September 12, 2012

**Re: REVISED ADMINISTRATIVE DRAFT REGIONAL MUNICIPAL SEPARATE
STORM SEWER SYSTEM (MS4) (Tentative Order No. R9-2012-0011)**

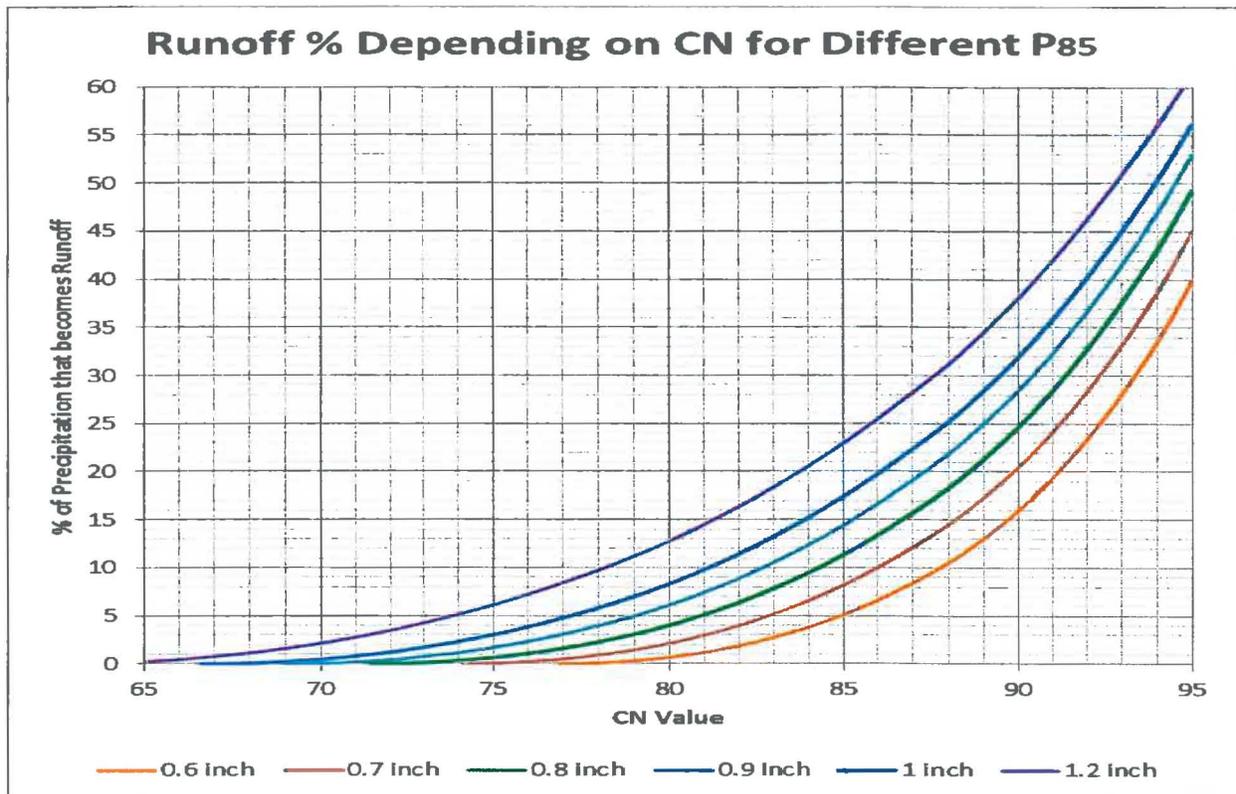
In San Diego County, many times the 24 hour - 85th percentile precipitation event (P₈₅) generates runoff in natural conditions, as impervious soils (Type D) are predominant in the County, and poor or fair natural vegetation is common in many areas. The Coalition has prepared a figure that illustrates the percentage of runoff as a function of the Curve Number value (a well-known parameter for hydrologists and engineers to determine runoff via NRCS (SCS) method, which is a function of soil type, vegetation, and AMC), for different values of P₈₅. It is clear that runoff as a percentage of the precipitation can be as small as 0% or as large as 60% depending on the conditions of the natural terrain and the size of P₈₅.

Each Priority Development Project must be required to implement LID BMPs that are sized and designed to retain the volume equivalent to the runoff volume produced from a 24-hour 85th percentile storm event produced in natural conditions. 15 (“design capture volume”);
